CSP 26-006AL (BP030) – ADDENDUM No.01
Willowridge HS Renovations

Fort Bend Independent School District
2023 Bond Program

addendum

PROJECT BP030 Willowridge High School Fine Arts Addition and Renovation, 2023306
PROJECT NO. CSP 26-006AL
ADDENDUM NO. 001
BID PACKAGE ISSUE FOR BID AND PERMIT

SHEET NUMBER
E2.32

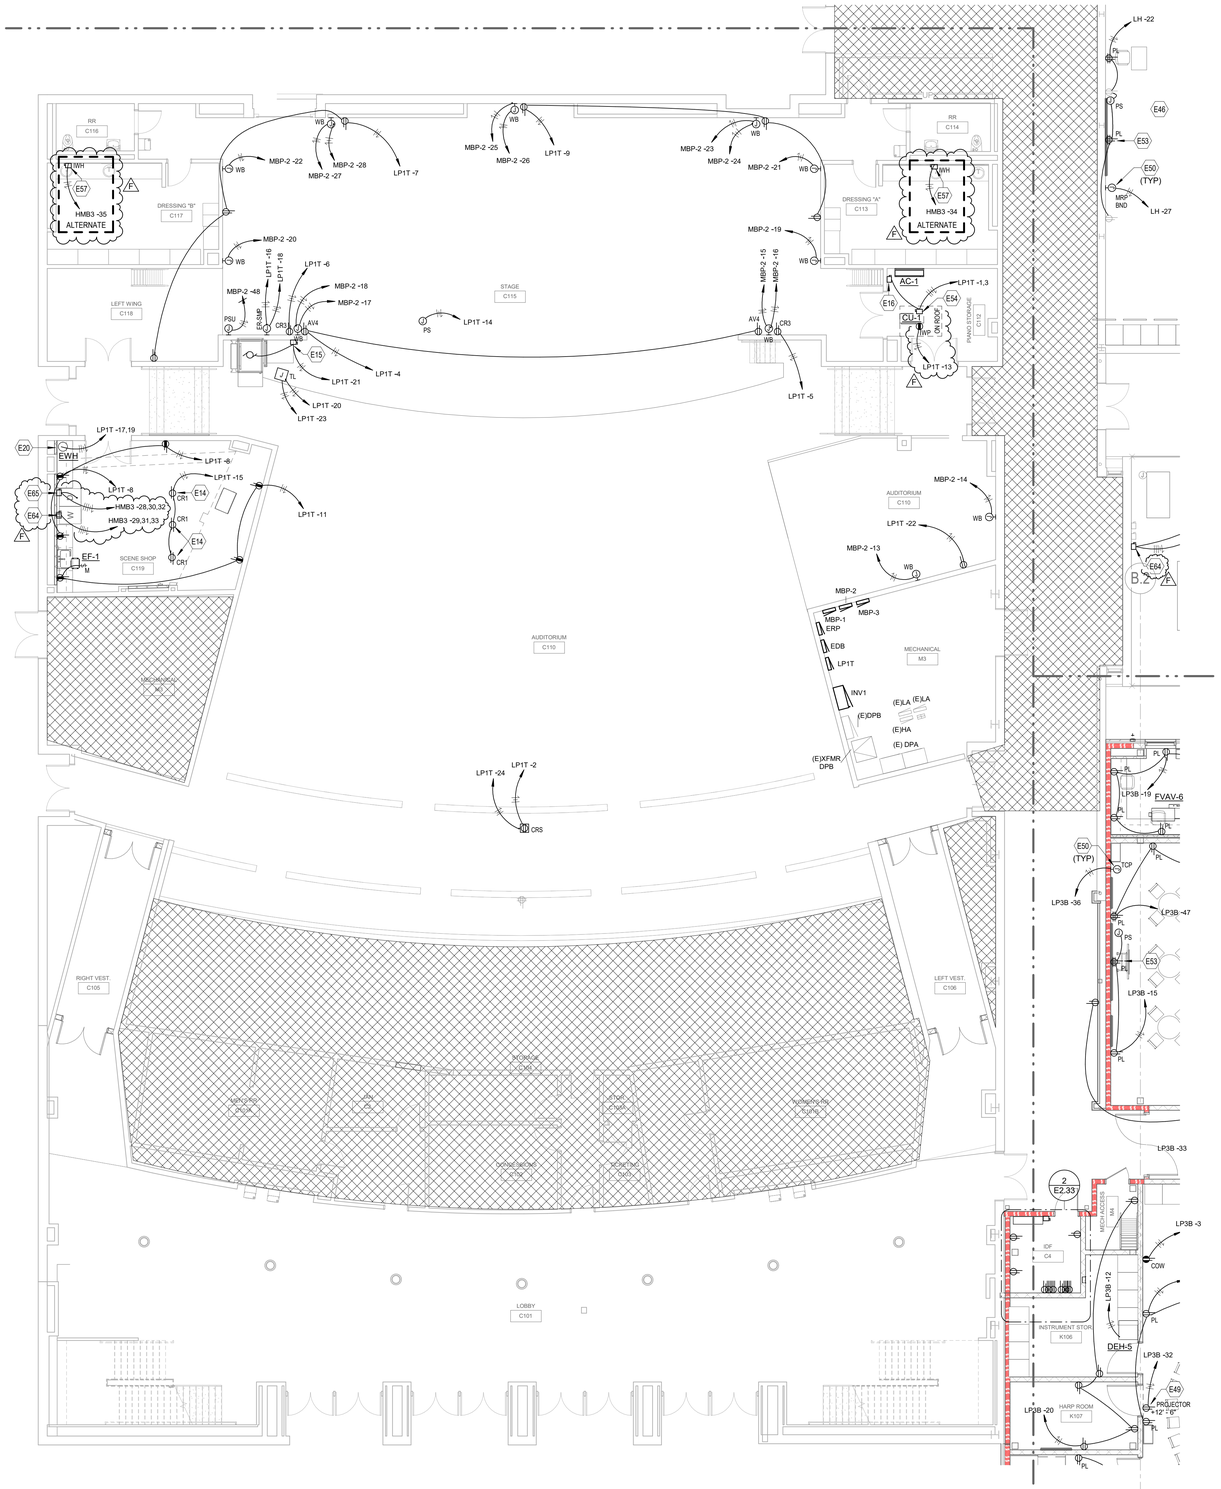
E2.32 LEVEL 1 POWER FLOOR PLAN – AREA B2

1. Weatherproof duplex added for CU-1 unit on roof and circuited to panel LP1T.
2. Tagged note E54 modified to change Nema type for disconnect from type 1 to 3R for CU-1.
3. Scene shop
    a. Power for washer and dryer revised to 480V/3Ph power as shown and circuited to panel HMB3. Tagged noted E64 and E65 added to sheet for disconnect sizes.
4. Alternate for instantaneous waters heaters added in dressing rooms. Power location added in each dressing room and circuited to panel HMB3. Tagged note E57 added to sheet.

SHEET NUMBER
E2.33

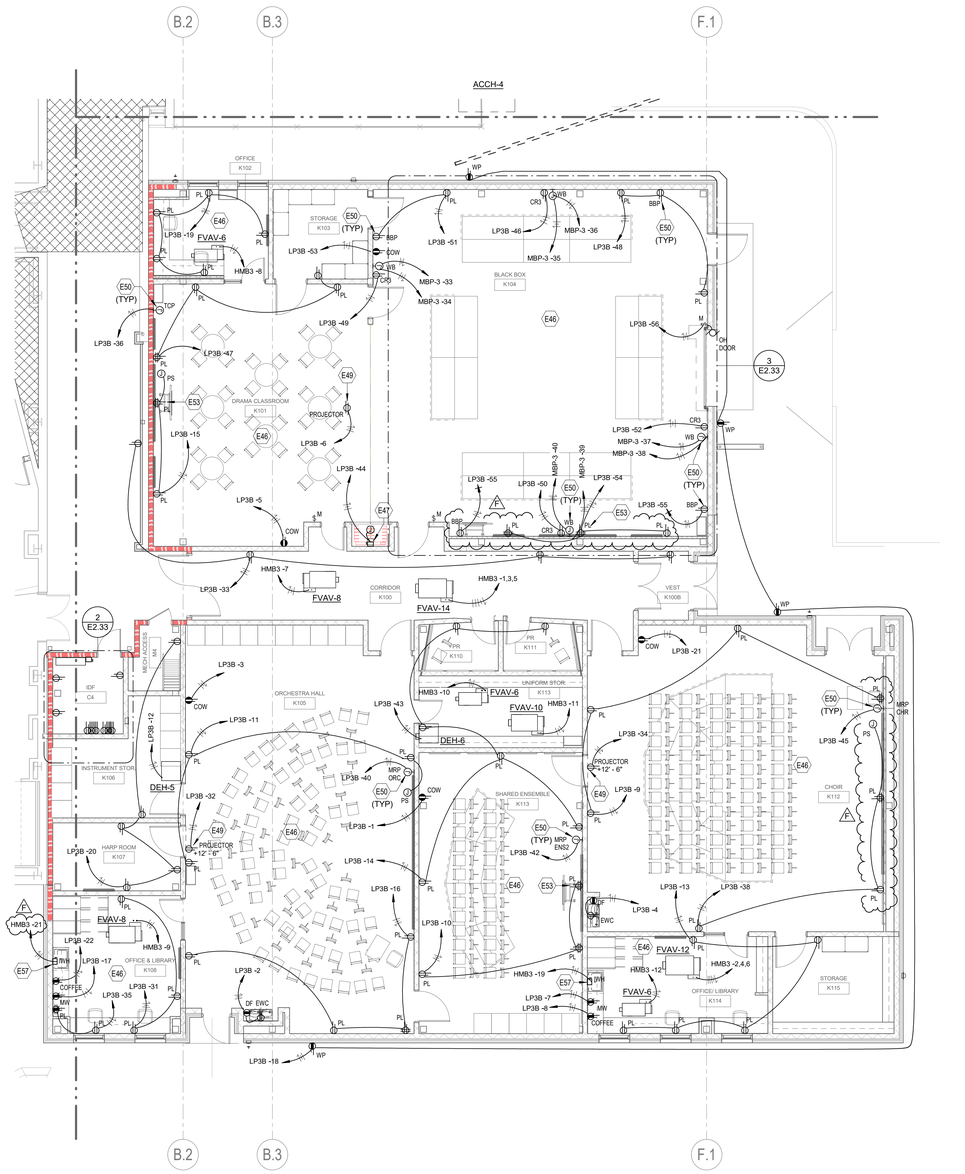
E2.33 LEVEL 1 POWER FLOOR PLAN – AREA B3

1. Panel and circuit number clarified for IWH power in K108 Office.
2. Power relocated in Black Box and Choir with added chase.

E2.36 LEVEL 2 POWER FLOOR PLAN - AREA B2

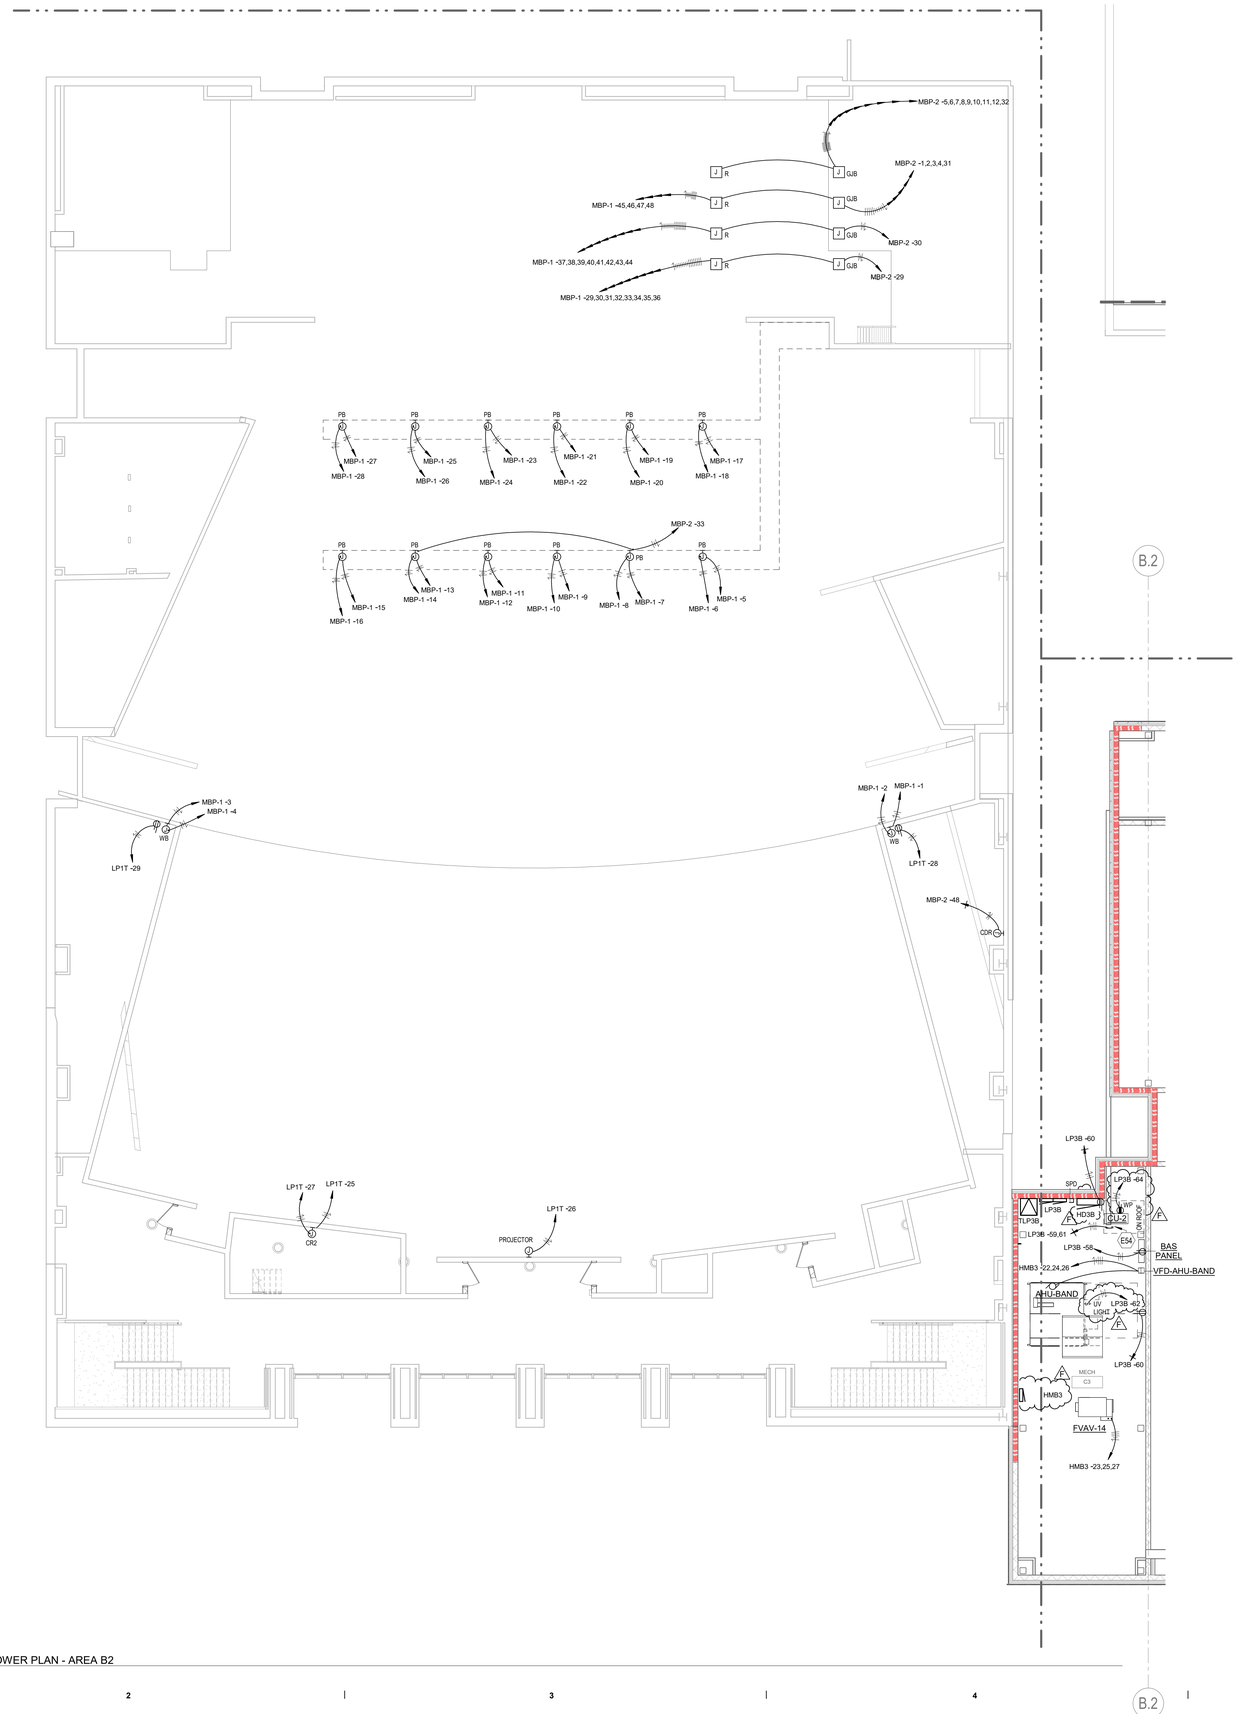
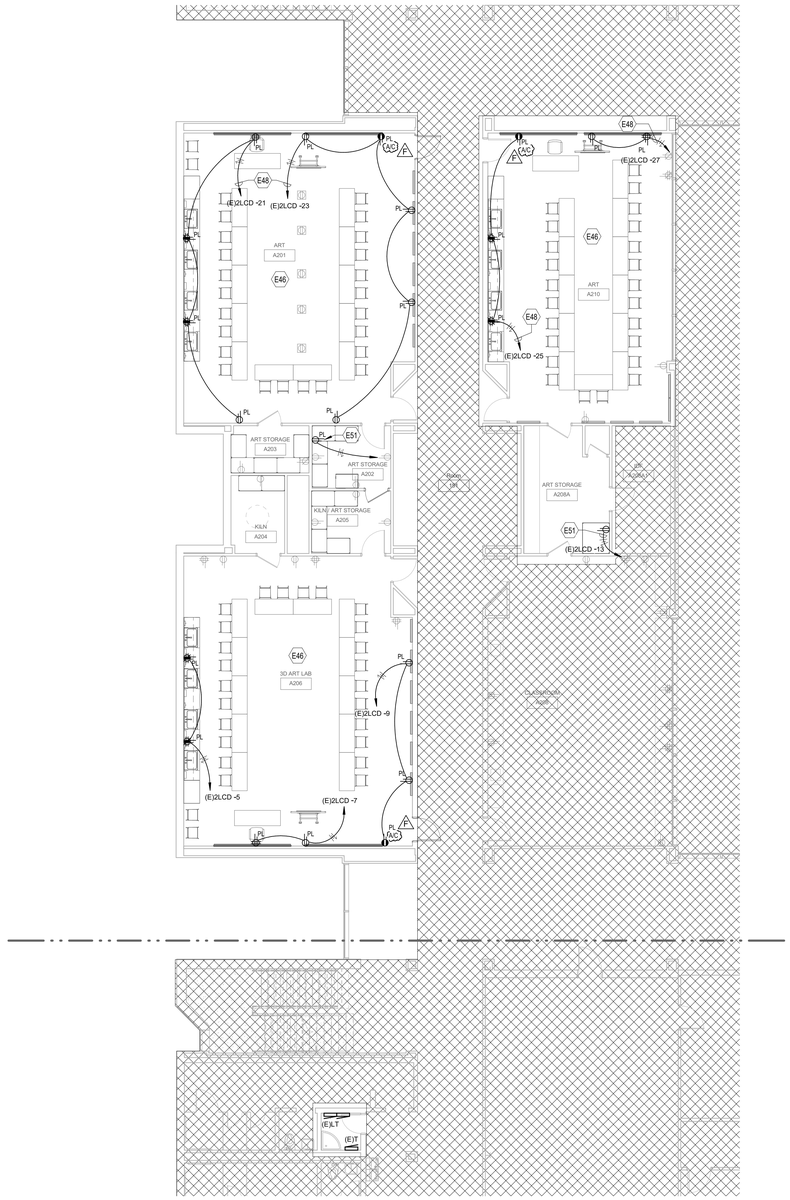
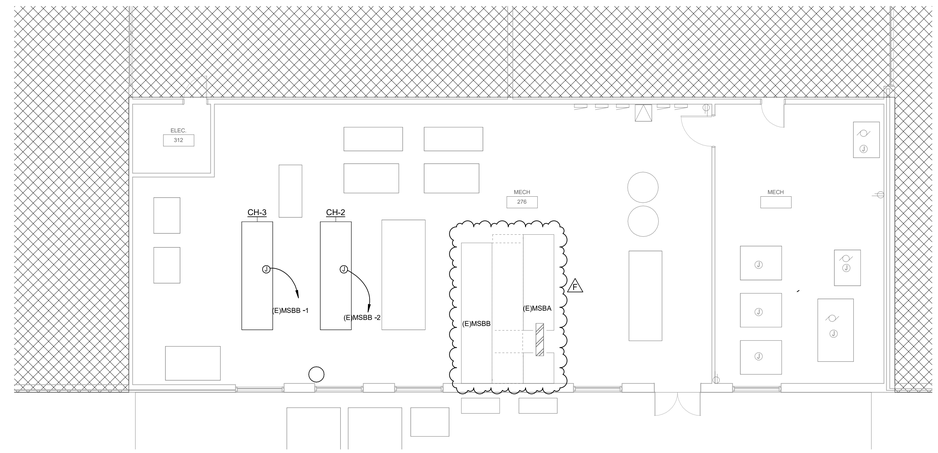
1. Weatherproof duplex added for CU-2 unit on roof and circuited to panel LP3B.
2. Tagged note E54 modified to change Nema type for disconnect from type 1 to 3R for CU-2.
3. Power location for AHU-BAND UV lights added and circuited to panel LP3B.
4. Added panelboard HD3B to the platform.

1 LEVEL 1 LIGHTING FLOOR PLAN - AREA B2
1/8" = 1'-0"

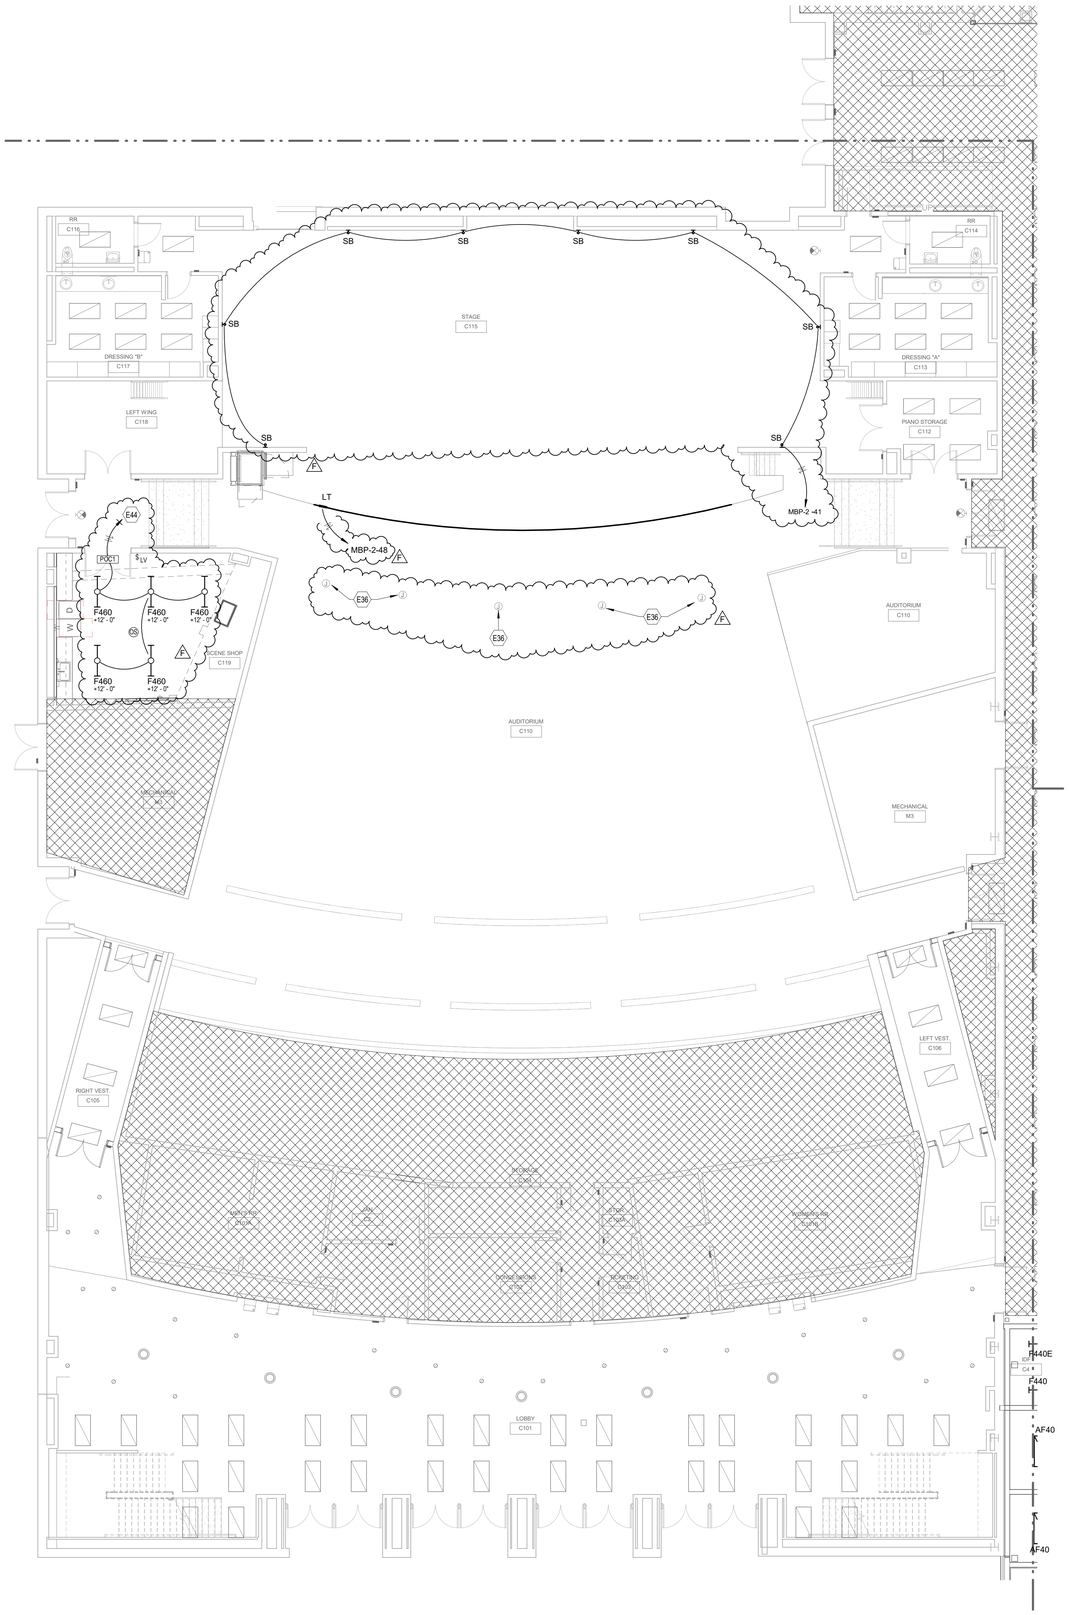
E3.32 LEVEL 1 LIGHTING FLOOR PLAN - AREA B2

1. Ten (10) new cylinder pendants over stage removed. Lighting in this area shown on level 2.
2. Blue lights added type SB and circuited to MBP-2.
3. Tagged note E36 added to sheet for alternate seating lighting.
4. Scene Shop
    a. Strip fixtures revised to type F460 and one additional light added in room.
    b. Tagged note E44 added to clarify lighting to be connected to existing lighting circuit in room.
    c. Occupancy sensor added.

1 LEVEL 1 LIGHTING FLOOR PLAN - AREA B3
1/8" = 1'-0"

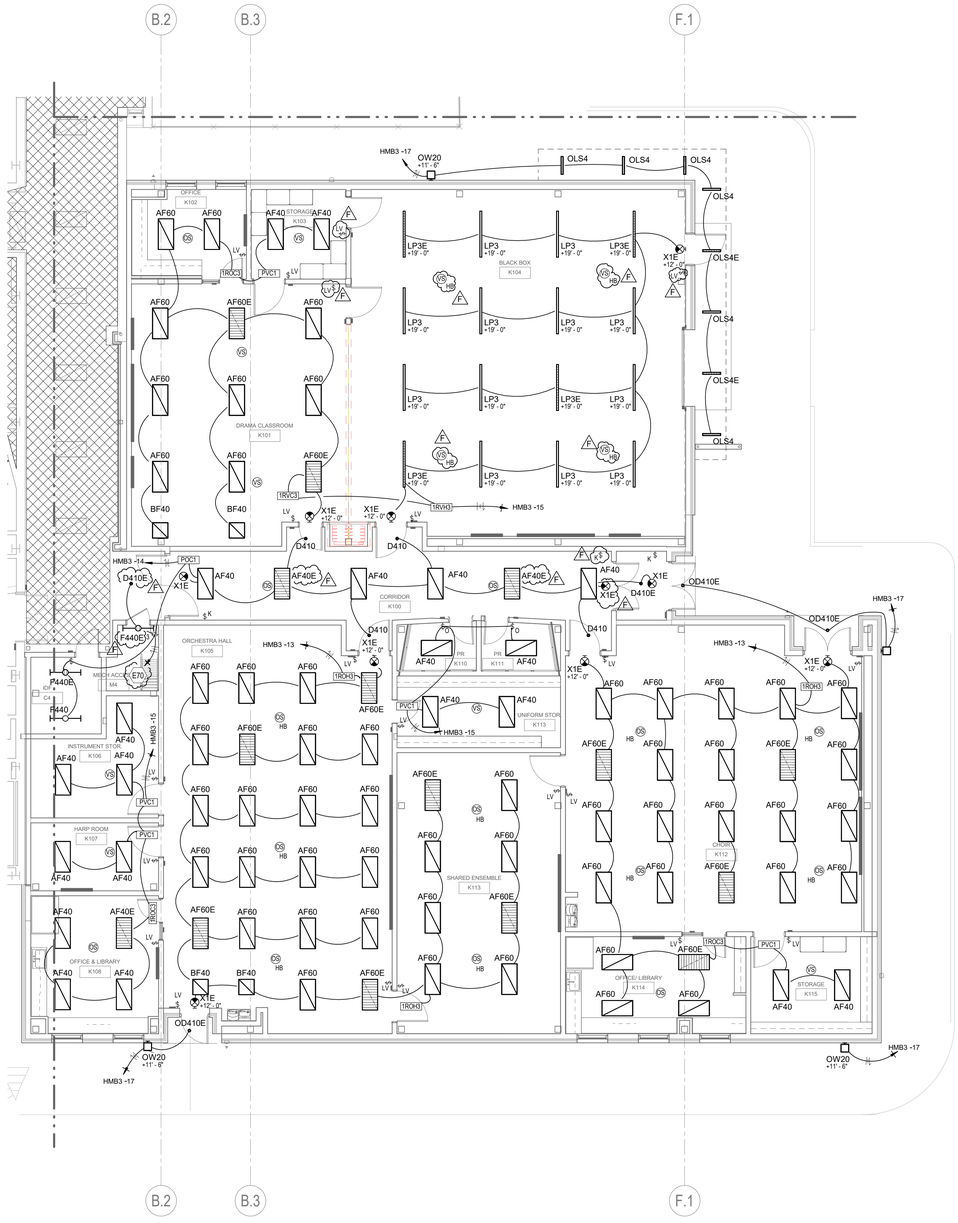
E3.33 LEVEL 1 LIGHTING FLOOR PLAN – AREA B3

1. Changed vacancy sensors in Black Box K104 to high bay vacancy sensors.
2. Changed two (2) fixtures in Corridor K100 AF40 fixtures to AF40E.
3. Added exit sign to Corridor K100.
4. Changed D410 in Corridor K100 to D410E.
5. Added Key switch to Corridor K100.
6. Changed F440 in Mech Access M4 to F440E to provide battery backup.
7. Added low voltage switch to storage K103, drama classroom K101, and in black box K104.
8. Adjusted the lighting layout in Mech C3 and removed one light fixture.
